Serial: NPD-NRC-2009-048
March 31, 2009

**LEVY NUCLEAR POWER PLANT, UNITS 1 AND 2
DOCKET NOS. 52-029 AND 52-030
RESPONSE TO REQUEST FOR ADDITIONAL INFORMATION LETTER NO. 010 RELATED TO
QUALITY ASSURANCE PROGRAM DESCRIPTION**

**Levy Nuclear Power Plant Units 1 and 2
Response to NRC Request for Additional Information Letter No. 010 Related to
SRP Section 17.5 for the Combined License Application, dated February 27, 2009**

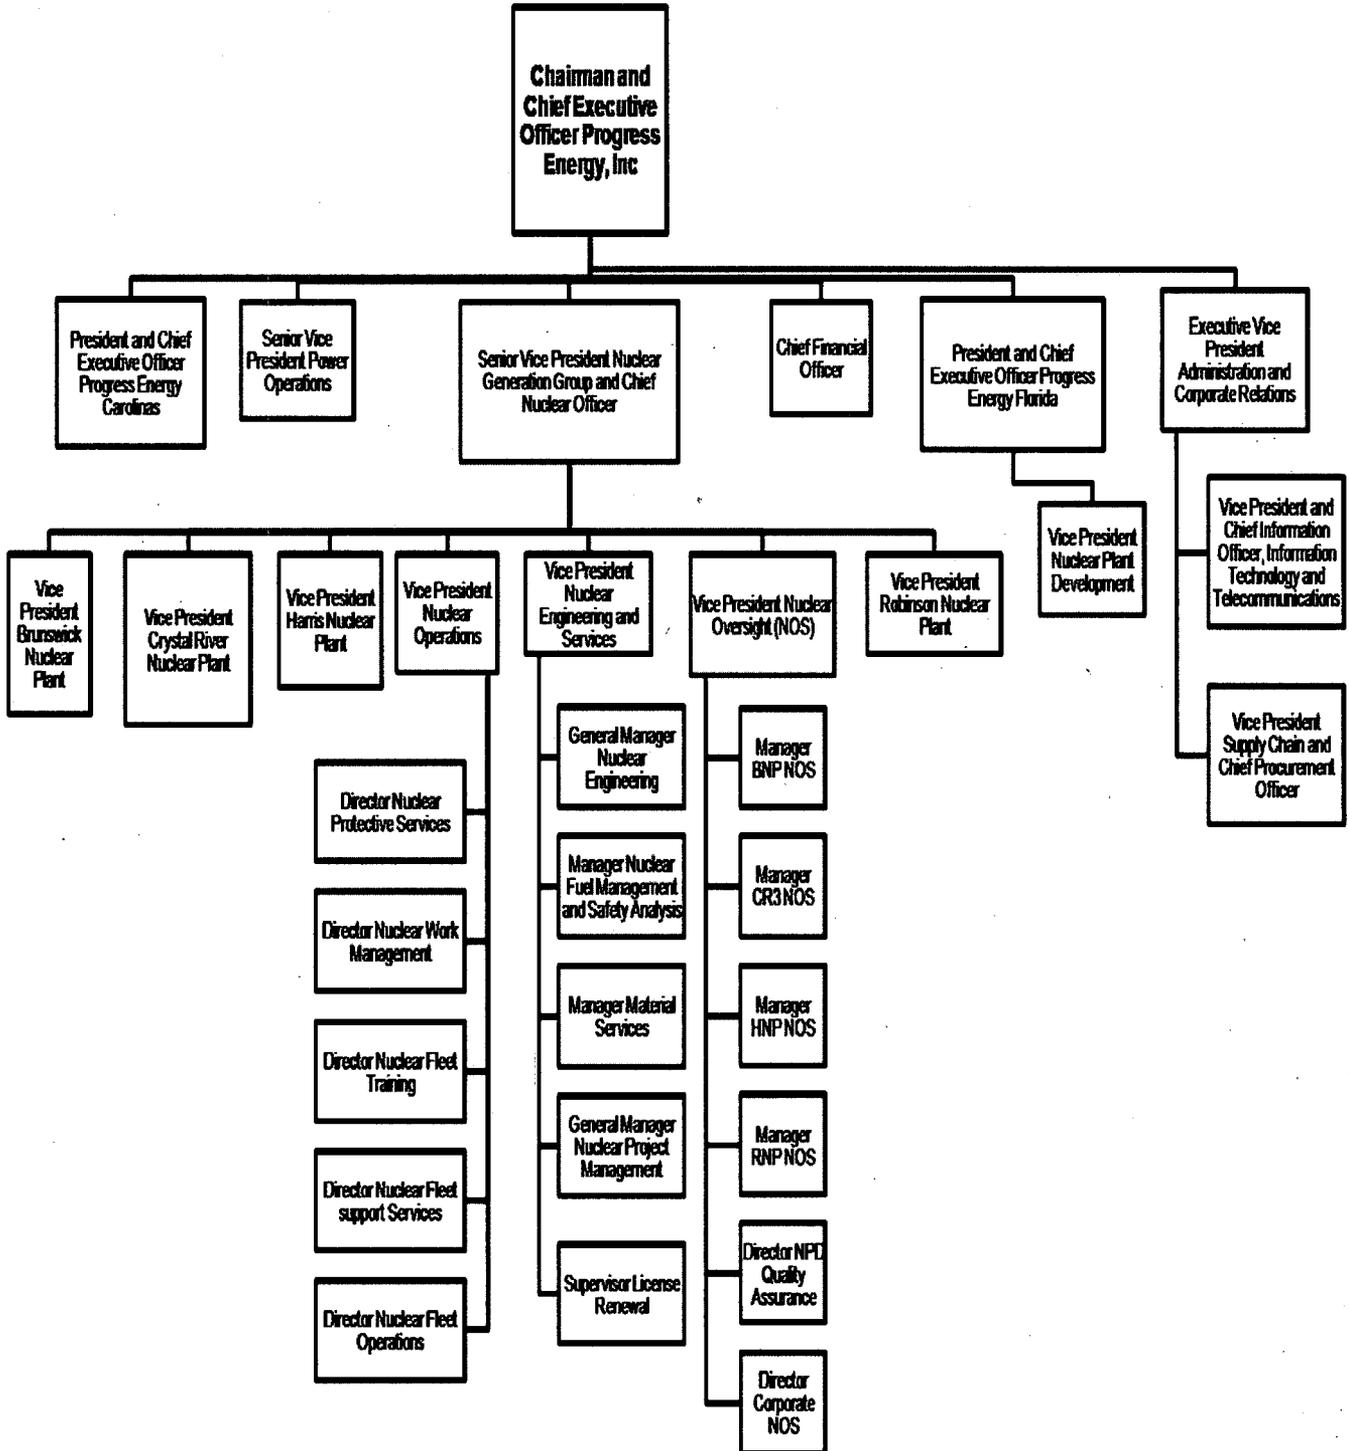
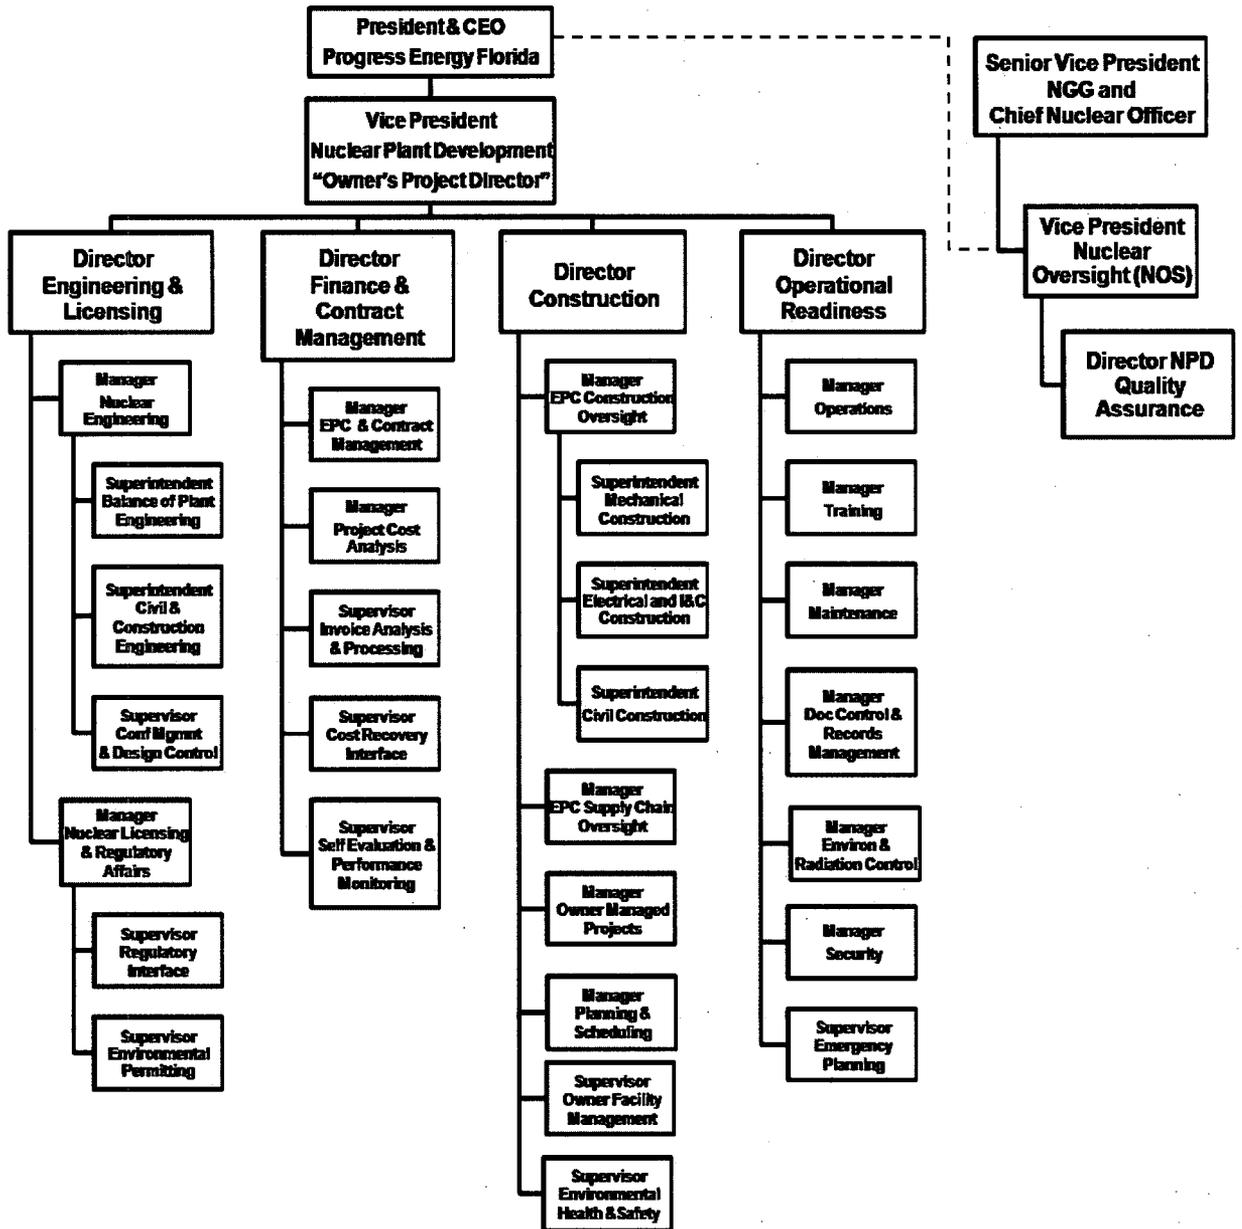
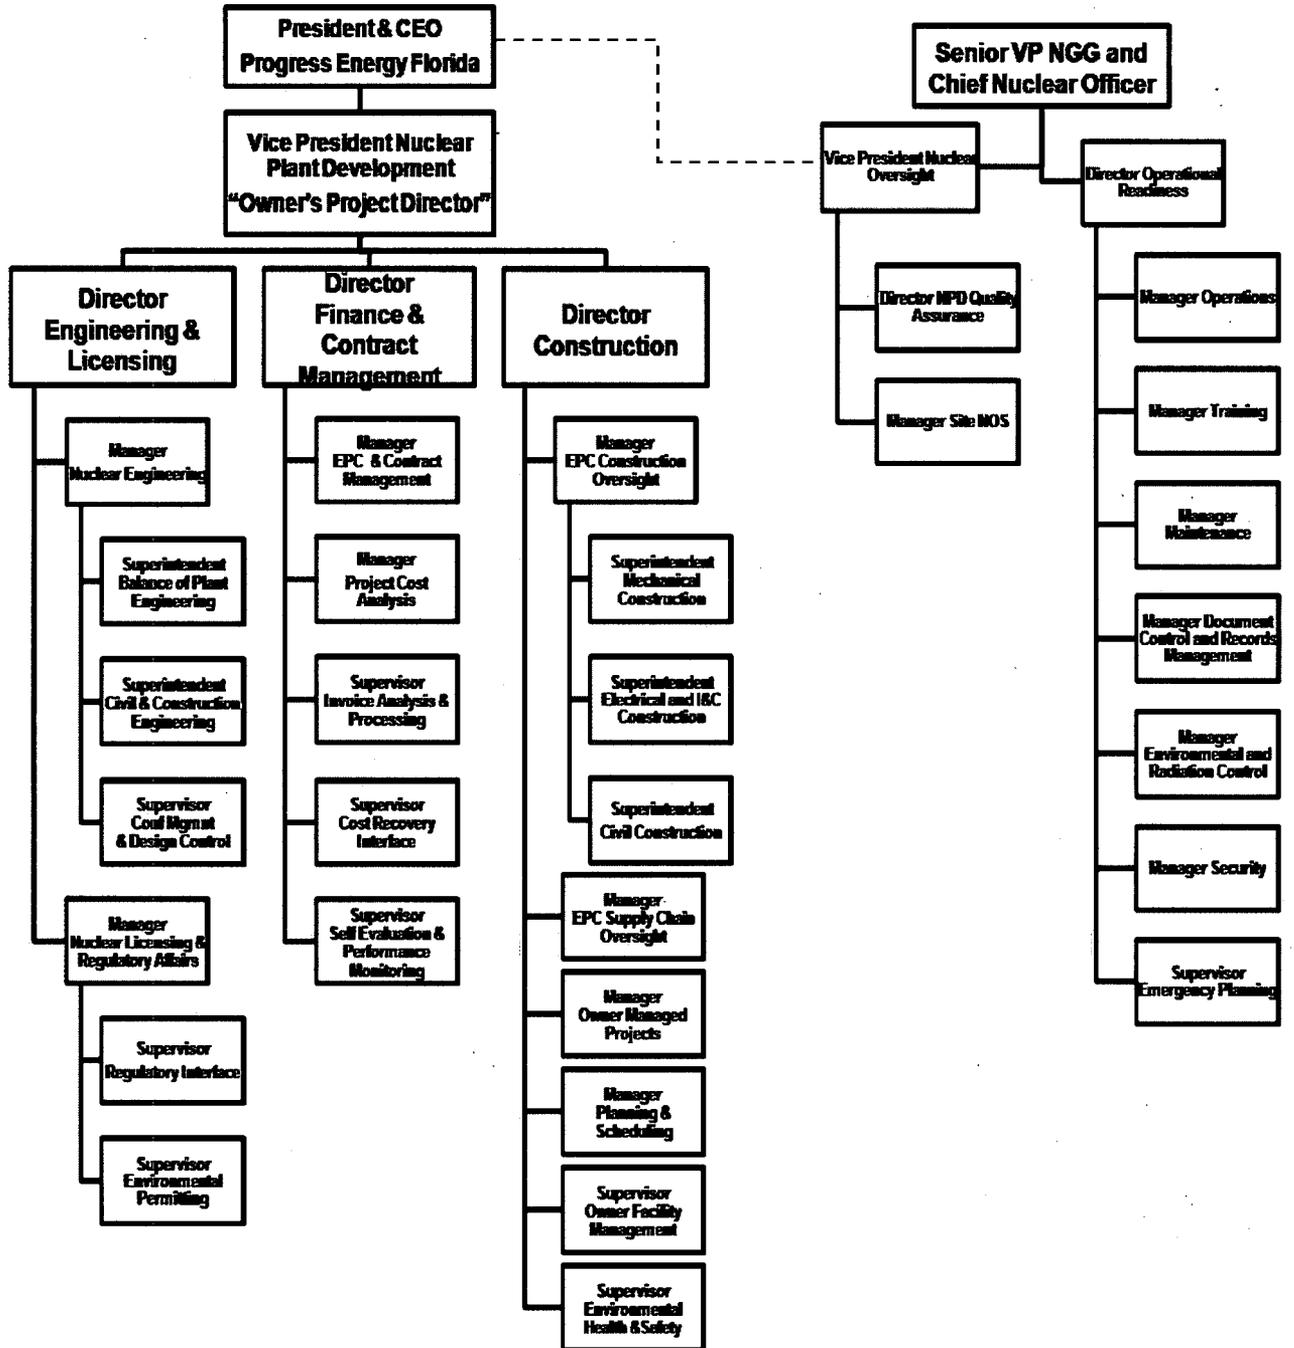
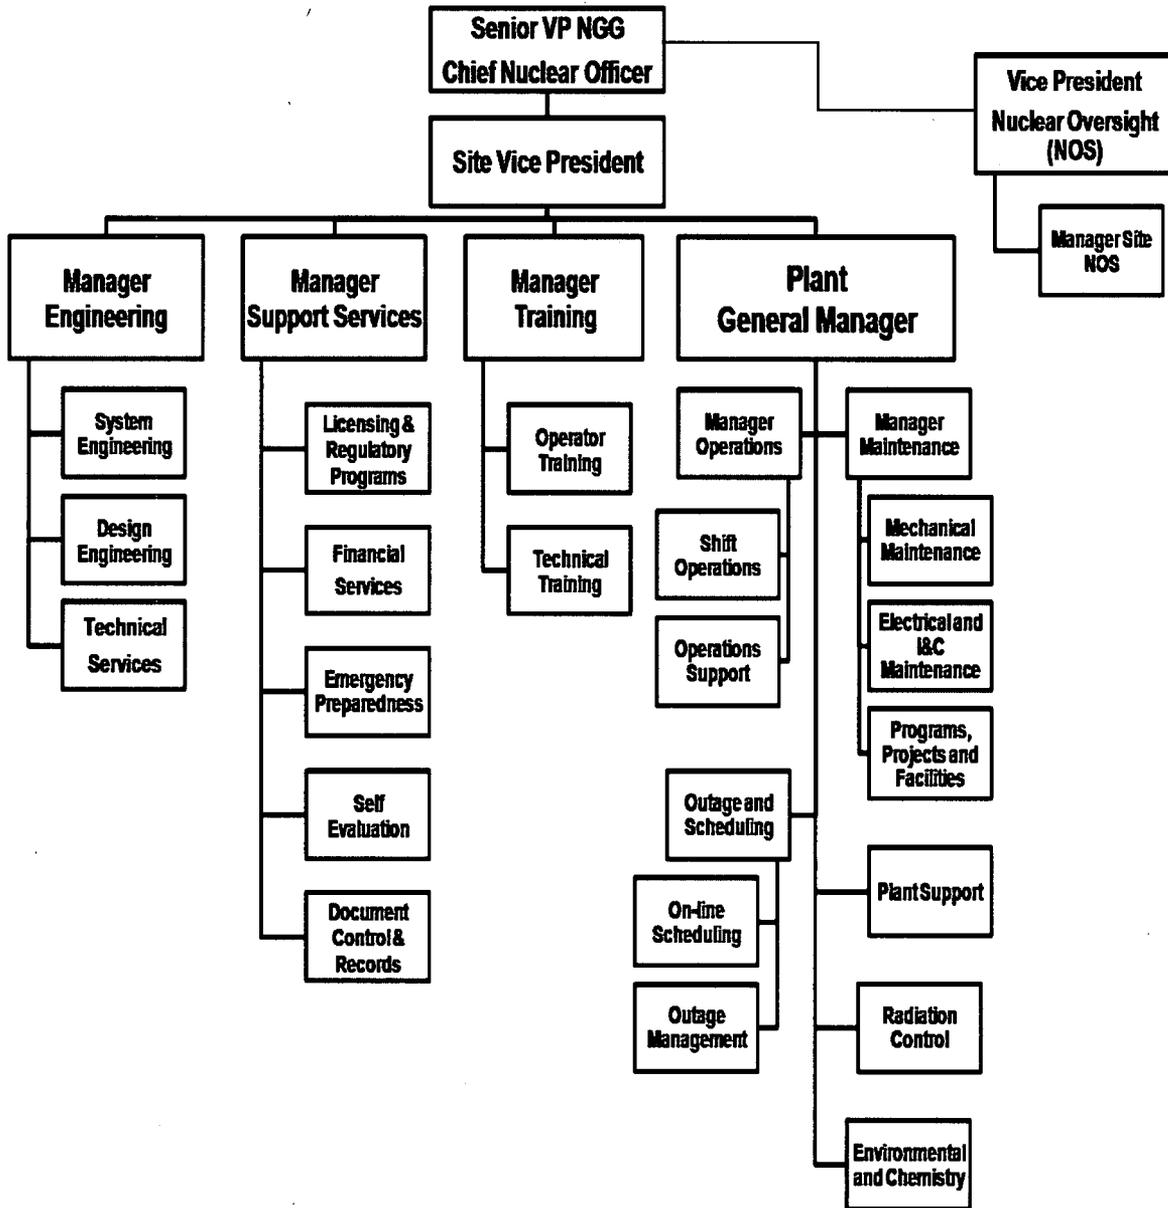
Organization (QAPD Part I, Section 1) FSAR Section 17.5 states that the QAPD is maintained as a separate document; whereas QAPD Part II, Section 1 states that organization charts for various departments/locations are contained in chapter 13 of the FSARs of the respective station. NEI 06-14A, "Quality Assurance Program Description," referenced by FSAR Section 17.5, includes charts typical of the construction/preoperational phase.

Because the QAPD is a stand-alone document, periodically submitted for NRC review, it should include organization charts for the construction/preoperational phase and the operations phase. These charts should depict the flow of responsibilities from corporate positions responsible for quality-related programs to and including positions responsible for implementing and verifying elements of these programs. Generic position titles, descriptive of position functions and supplemented by descriptive text, may be used.

The QAPD describes the functions and responsibilities associated with the quality assurance requirements of Appendix B, Criteria I, Organization, Criteria II, Quality Assurance, and the administrative requirements described by American National Standard Institute (ANSI) N18.7. All positions associated with the establishment, implementation, and verification of quality-related activities should be shown on the organization charts and described in the QAPD.

For the operations phase, the level of detail to be included should include roles, responsibilities, and lines of authority for the positions necessary to implement the requirements of N18.7. Comparable detail should be provided for the construction/preoperational phase.

The Progress Energy QAPD, Progress Energy New Nuclear Plant Quality Assurance Program Description Topical Report, was developed to support use of the document as a topical report applicable to all new nuclear generating plants developed and implemented by Progress Energy. The same QAPD document was submitted as Part 11 of both the Shearon Harris Nuclear Power Plant Units 2 and 3 and Levy Nuclear Plant Units 1 and 2 COL applications. As such the document was written in a generic nature without specific reference to any unit or site. The organizational descriptions and organization charts contained within the QAPD define the corporate and Nuclear Generation Group organizations that implement the quality assurance requirements in the QAPD in support of the development, construction and operation of the units. The operational phase organization chart provided in the QAPD is representative of the typical site organizational structure identifying the various reporting relationships that implement the quality assurance requirements including Nuclear Oversight functions. Since both the FSAR Chapter 13 and the QAPD require an operational phase organizational description, and the QAPD was designed to be generic and non site specific, Progress Energy elects to describe the detailed organization responsible for the operation of the new nuclear generating plants within the respective sites' FSAR Chapter 13. This detailed description is incorporated by reference into the QAPD, and changes to this organization are reviewed under the provisions of 10 CFR 50.54(a) to ensure that any reduction in commitments contained in the QAPD (as accepted by the NRC) are submitted to and approved by the NRC prior to implementation. Chapter 13 of the Levy Nuclear Power Plant Units 1 and 2 will be revised as documented below to address this process.

Progress Energy has defined the organizational structure; roles and responsibilities; and reporting relationships for the Progress Energy, Inc. organizations that will implement the requirements of this QAPD for the development, construction and operation of new nuclear generating plants. The Nuclear Plant Development (NPD) Department was created and aligned to the President and Chief Executive Officer (CEO) –Progress Energy Florida (PEF) for the development and management of the construction efforts. NPD activities were removed from the Nuclear Generation Group (NGG) to separate the construction activities from the management of the operating nuclear units. Management of all operating nuclear units within the NGG remain the responsibility of the Senior Vice President NGG and Chief Nuclear Officer (CNO). As shown on Figure II.1-1 of the QAPD, both the President and CEO-PEF and the Senior VP NGG/CNO report directly to the Chairman and CEO, Progress Energy, Inc. This separation of responsibilities allows NGG management to remain focused on improving the performance of the operating units while minimizing distractions associated with the construction

of new nuclear units. Management responsibility for the newly completed units transitions between these two positions when the newly constructed unit is ready for operations. This transition occurs prior to loading fuel in the new nuclear unit. The changes to the QAPD Part II Section 1 Organization, which reflect this alignment as noted below defining the organizational roles, responsibilities and reporting relationships including organization charts, will be included in Revision 1 to this QAPD to be submitted in conjunction with the first annual update of the Levy Nuclear Power Plant Units 1 and 2 Final Safety Analysis Report.
